DP AUDIO VIDEO LLC
Model Difference

RE: LETTER OF MODEL DIFFERENCE

EUT NAME: CD Boombox

FCC ID:2AVRV100043854V2

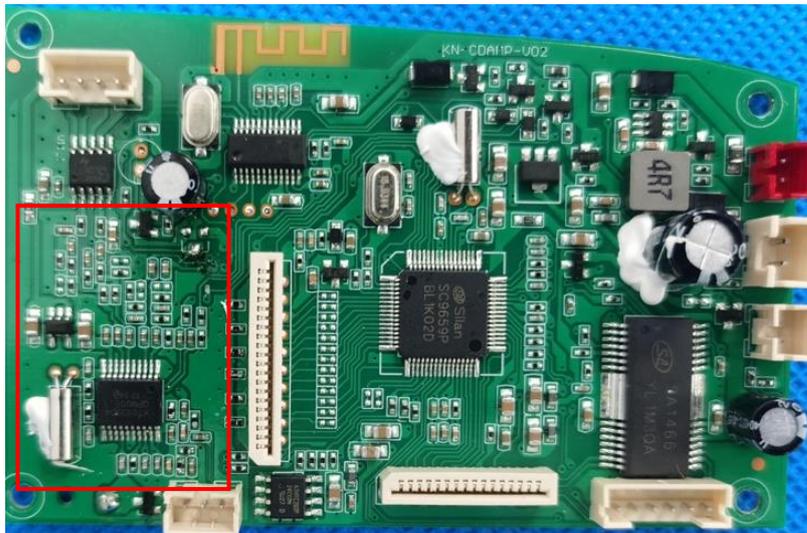
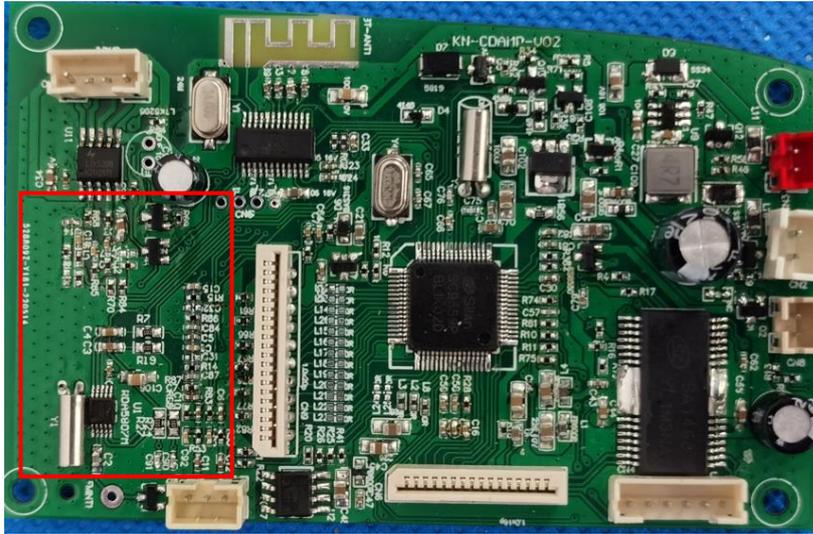
FM IC is different, so FM circuit and layout is different. The figure below is the part of the difference circuit marked. RF circuit has no change, which does not affect the RF part.

The first kind of FM IC Model: KT0923

The second kind of FM IC Model: RDA5807M
